A ROADRUNNER CONVENIENCE STORE SITE PLAN

ROADRUNNER CONVENIENCE STORE 87-6015-14

CONVERT FROM
TOTAL PETROLEUM
TO DIAMOND SHAMROCK

CASE NUMBER
1987-6015-04

| PROPOSED EXTERIOR ELEVATIONS DRAWN BY: RT DATE: 01-31-02 DRAWING NUMBER: 2793-02 | CHECKED BY: RT SCALE: 1/4"=1'-0" SHEET NUMBER: A3 |

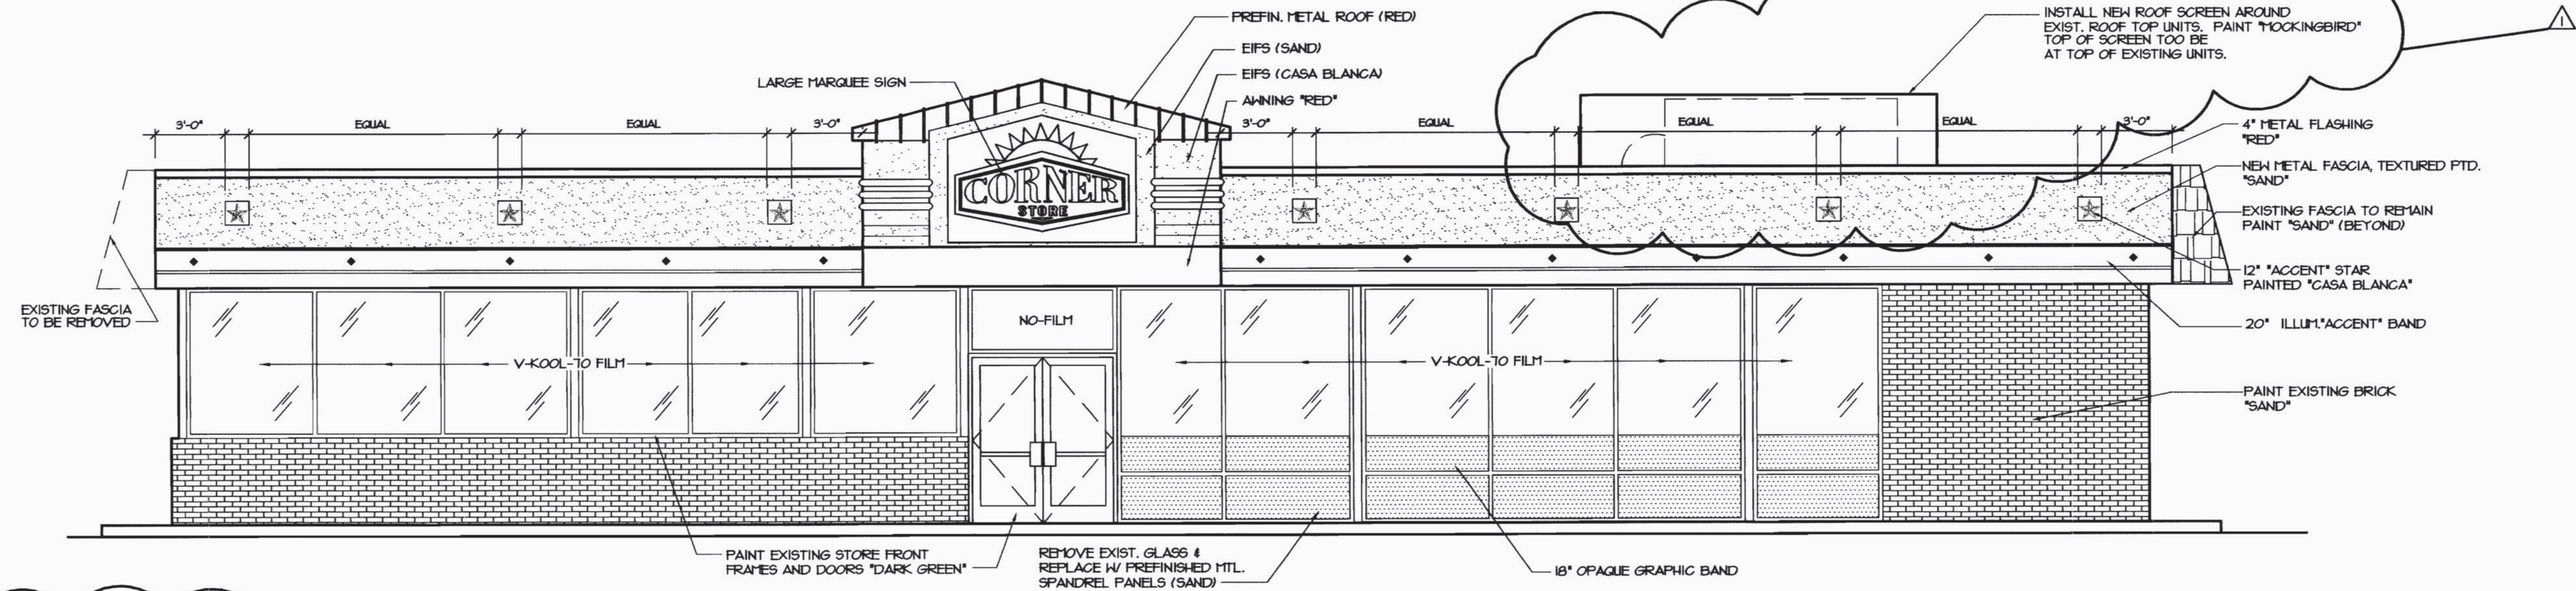
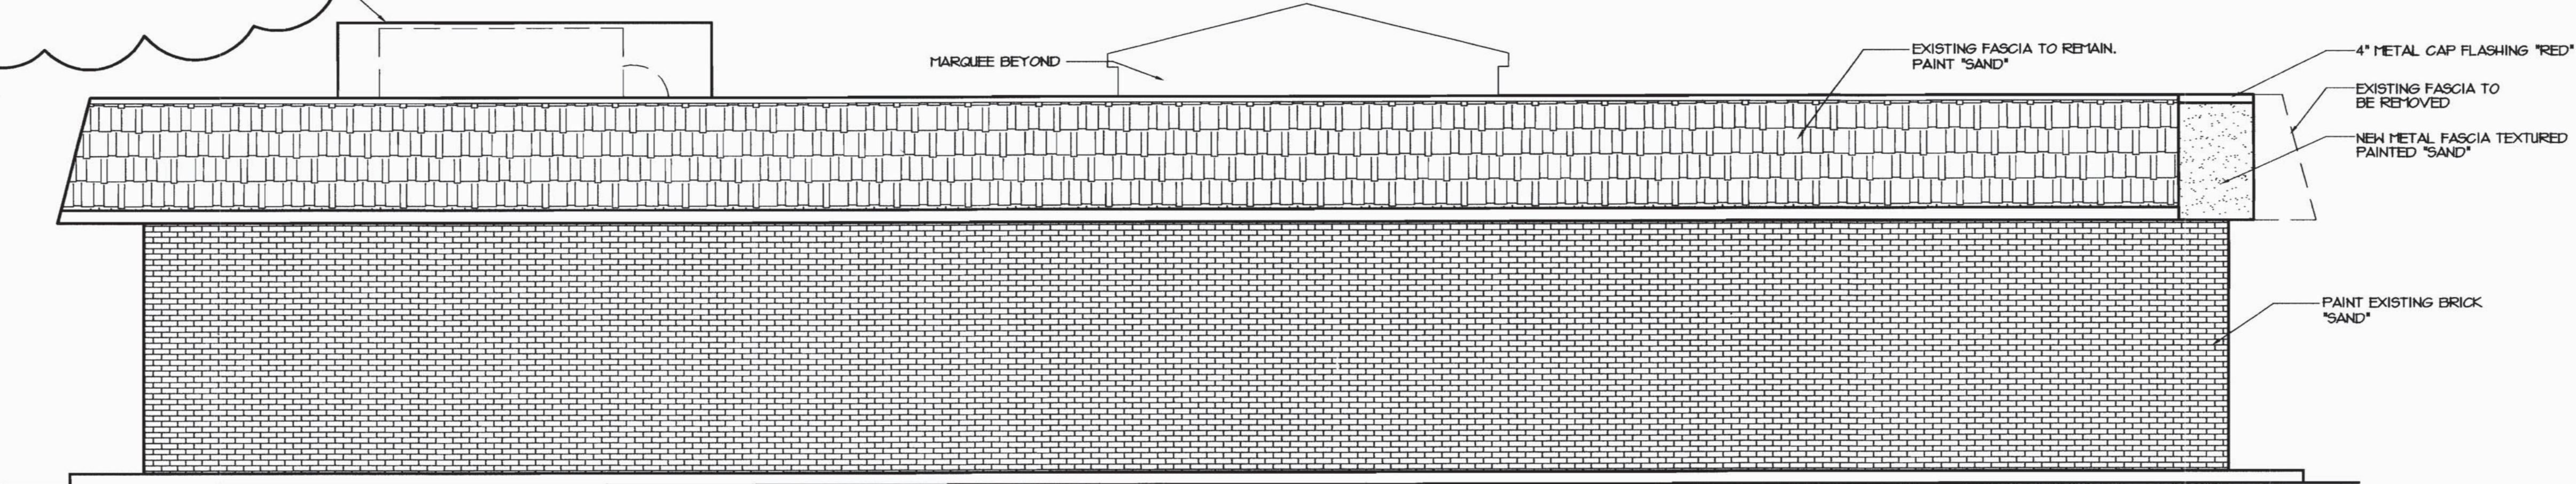
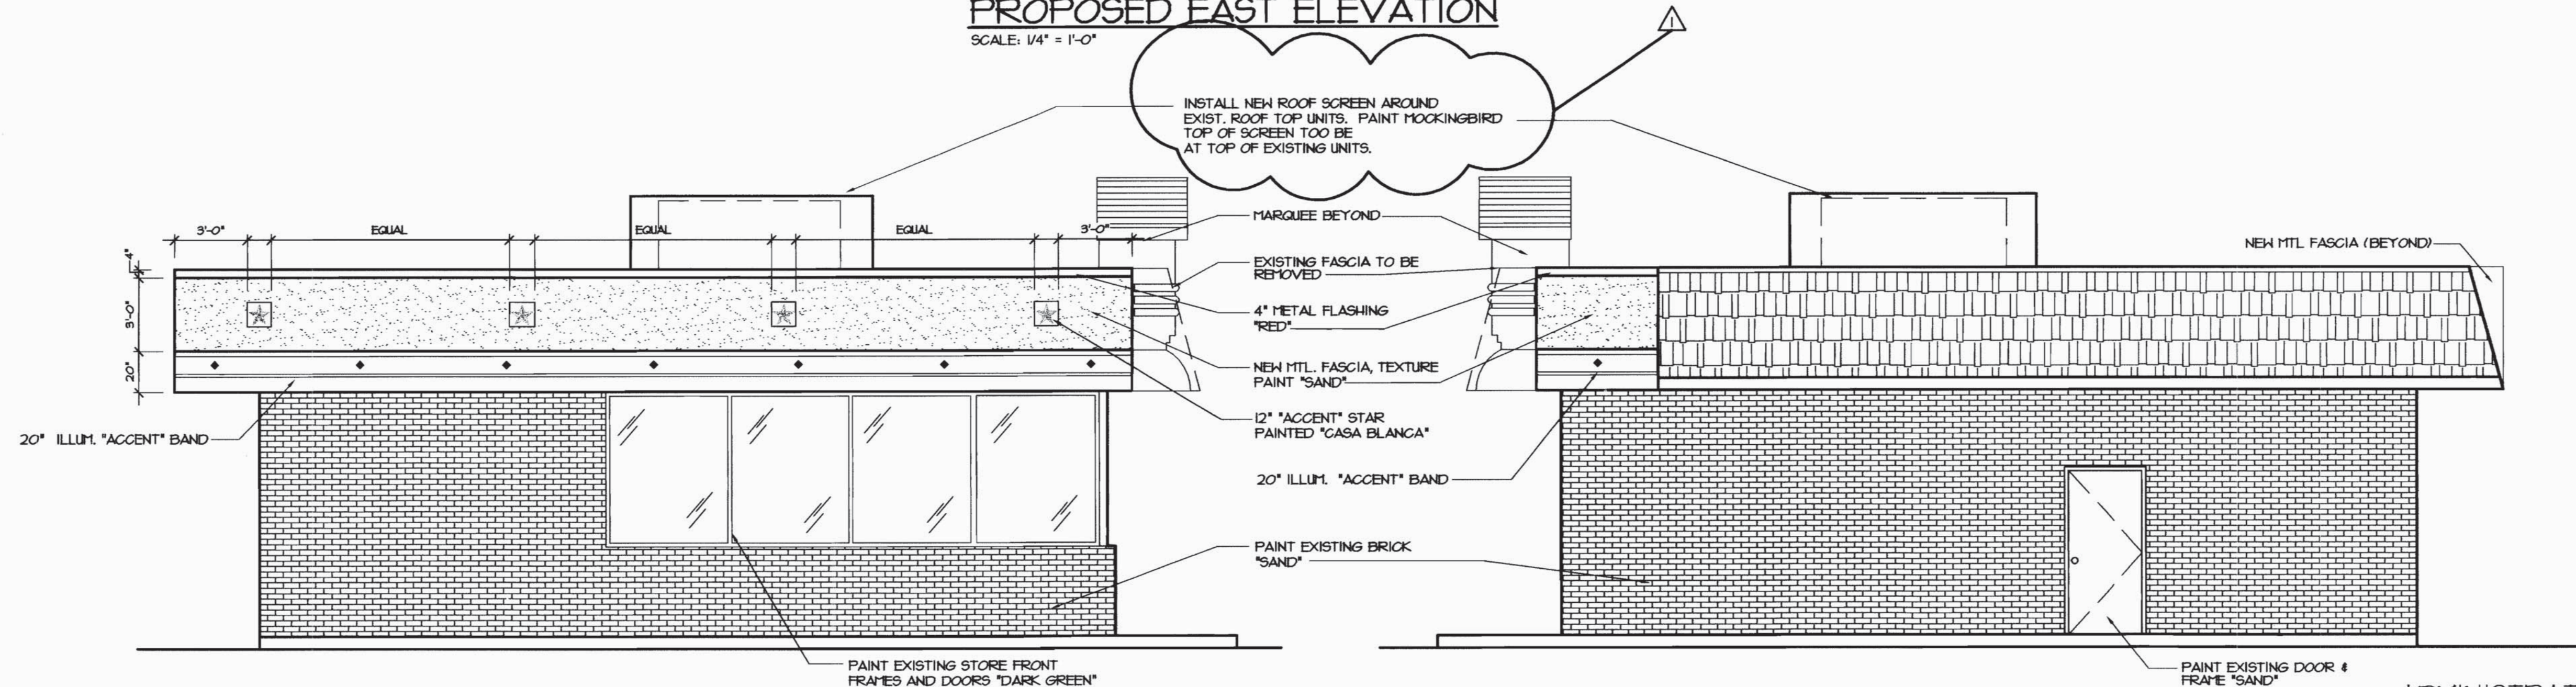
ADMINISTRATIVE AMENDMENT 7/08/02

△ CONVERT FROM TOTAL PETROLBIT TO DIAMOND SHAFT-ROCK

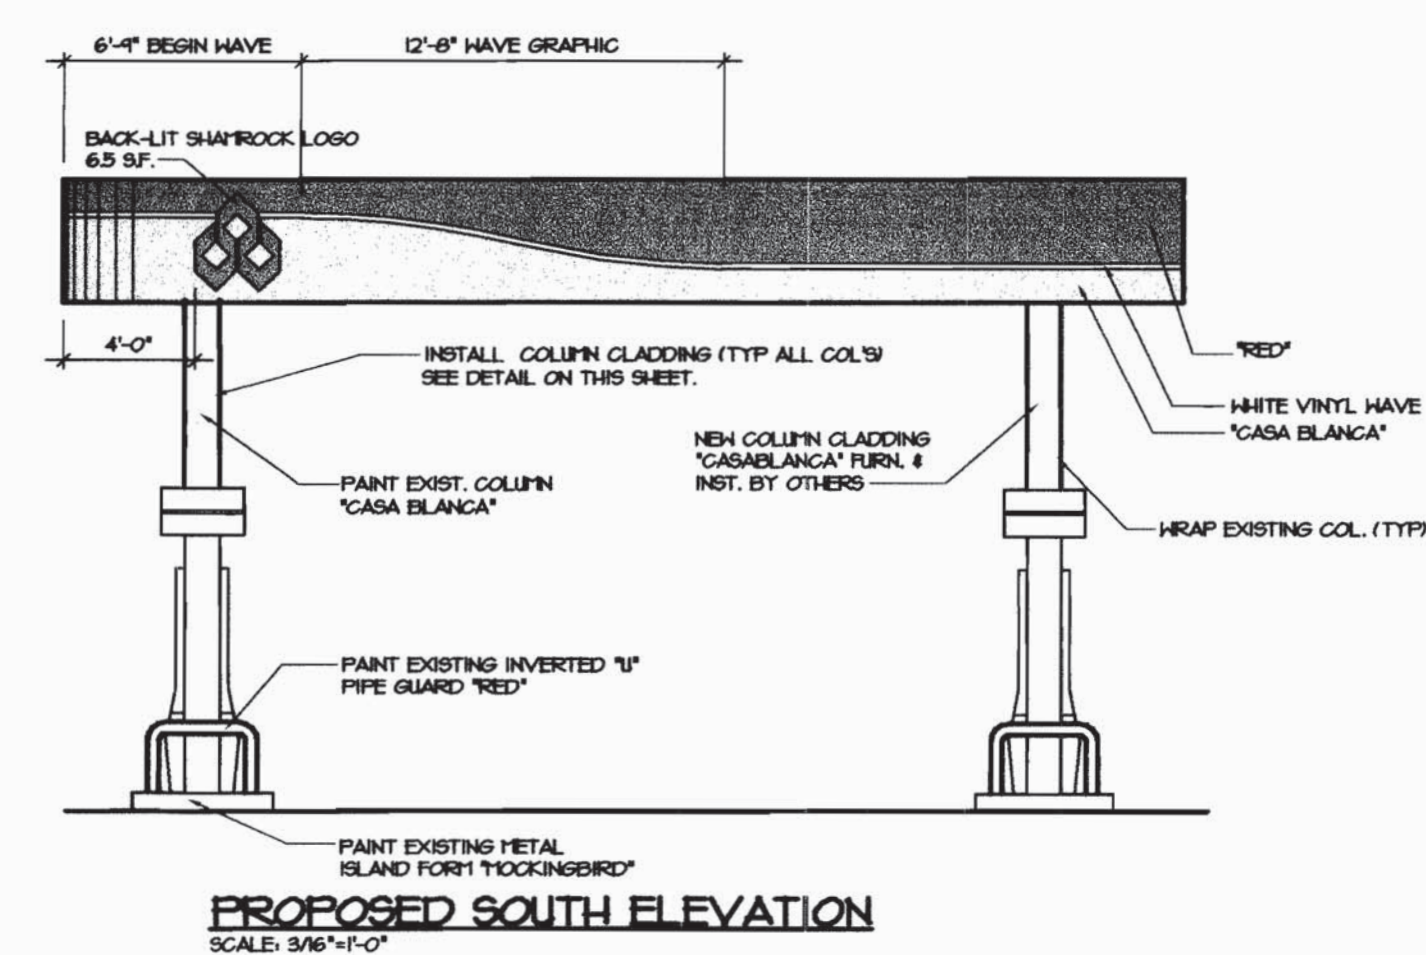
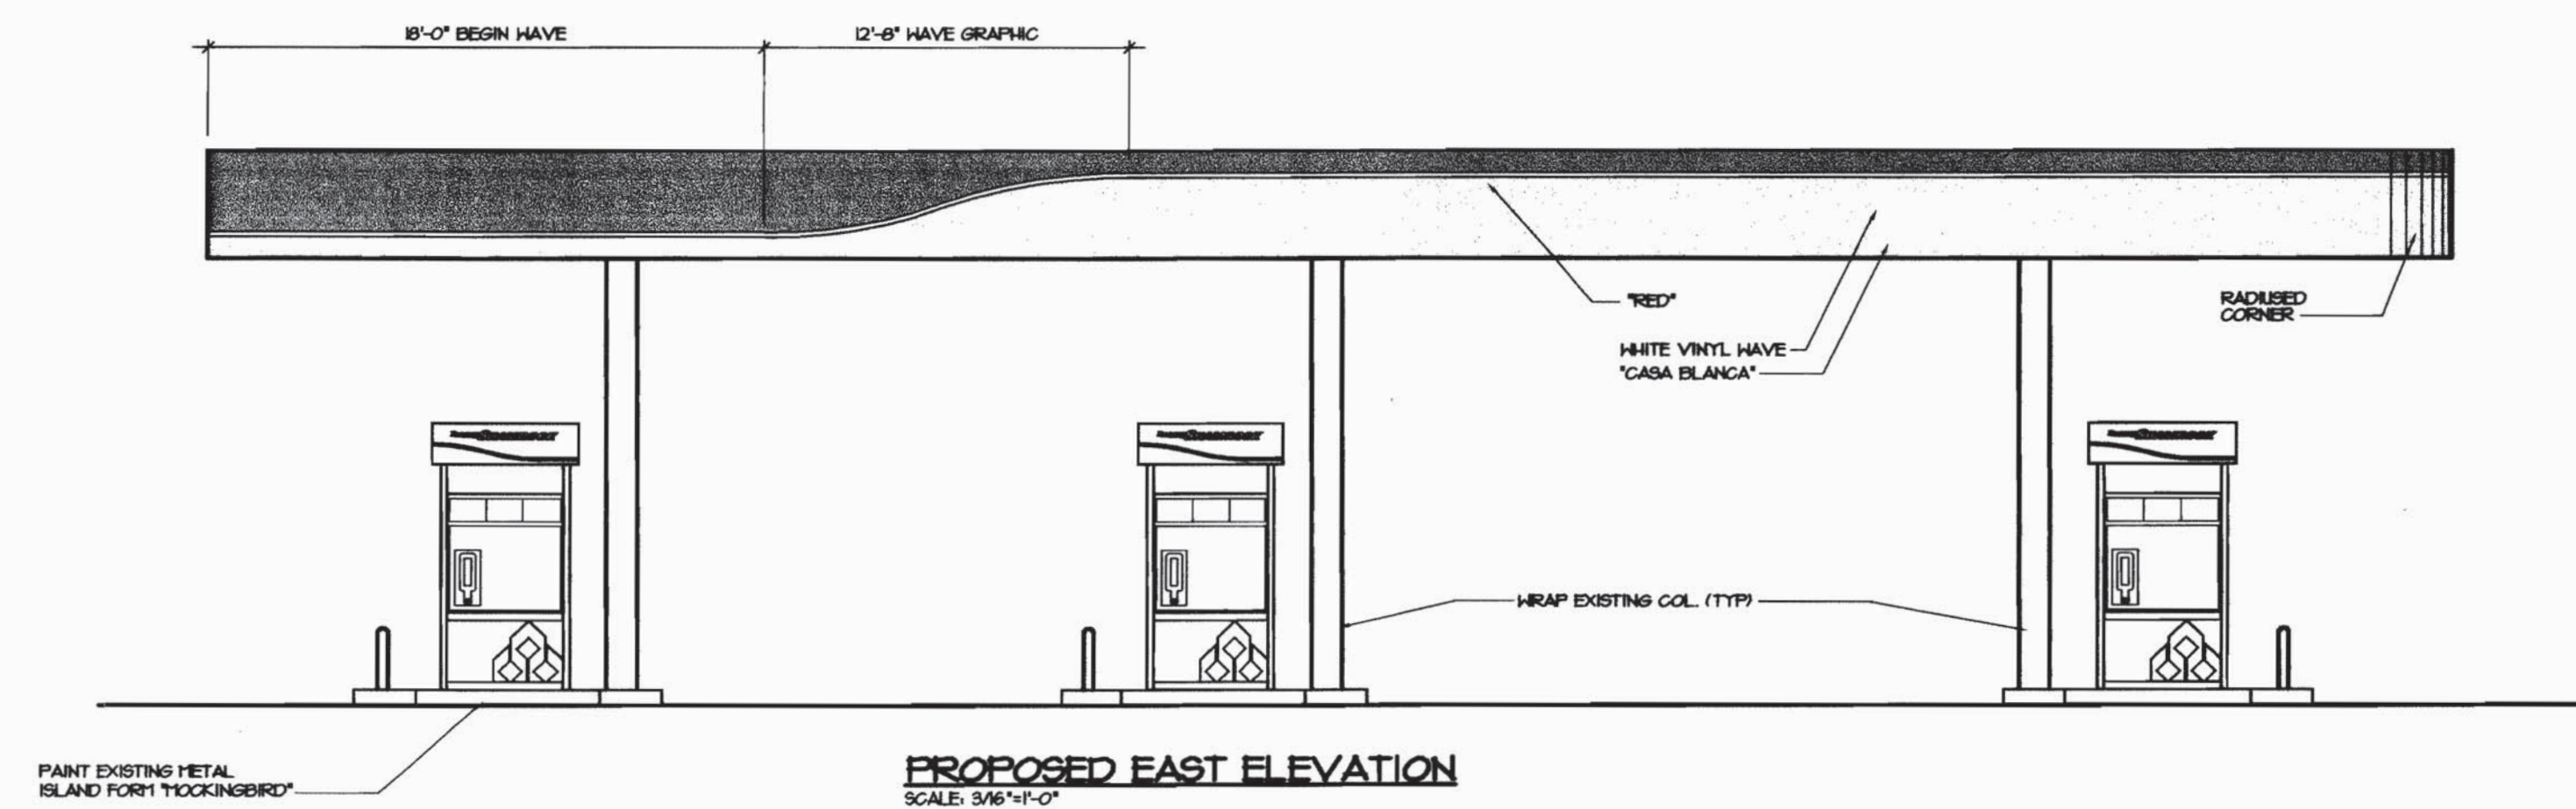
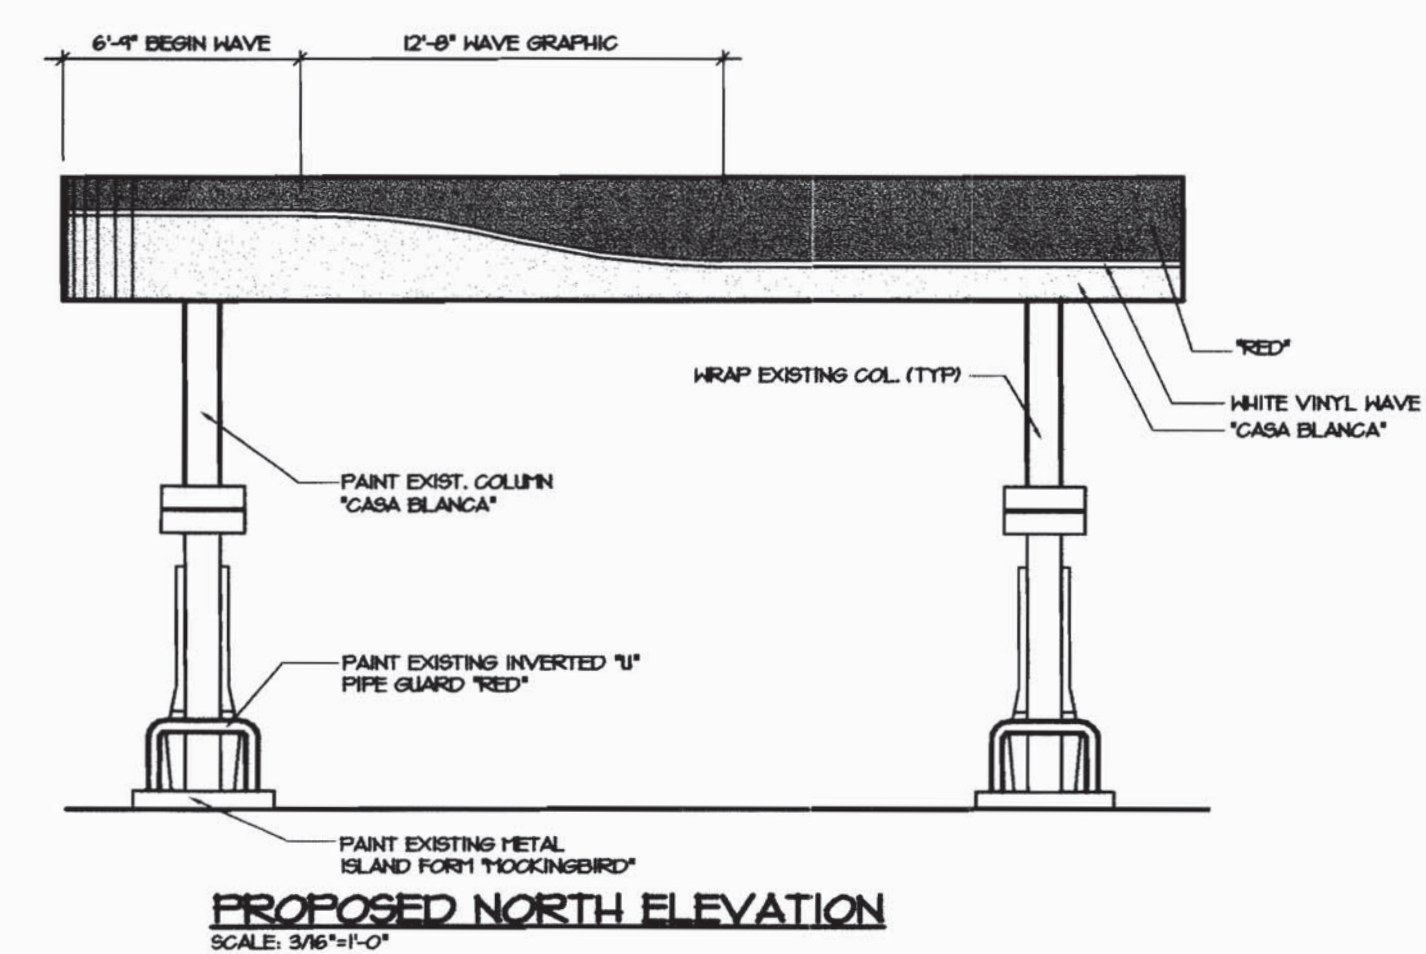
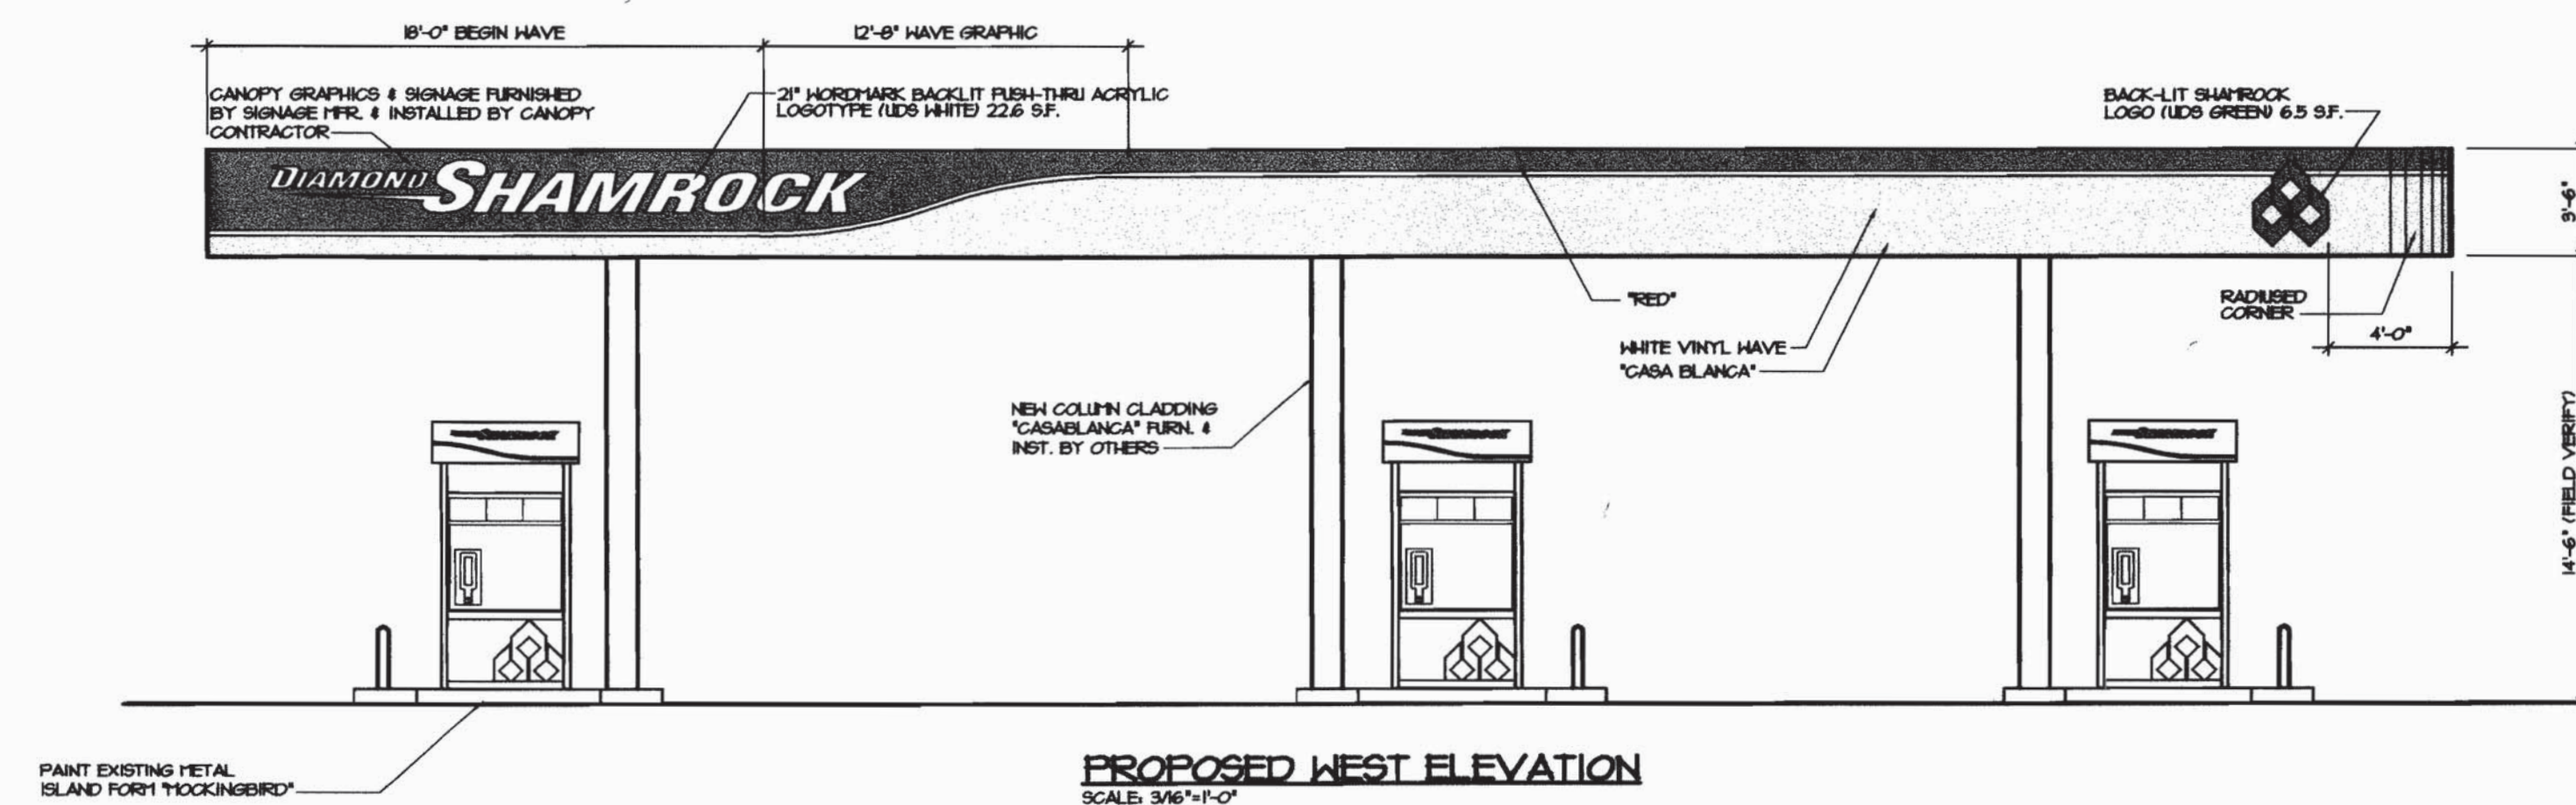
ADMINISTRATIVE AMENDMENT 7/08/02

CONVERT FROM
TOTAL PETROLEUM
TO DIAMOND SHAMROCK
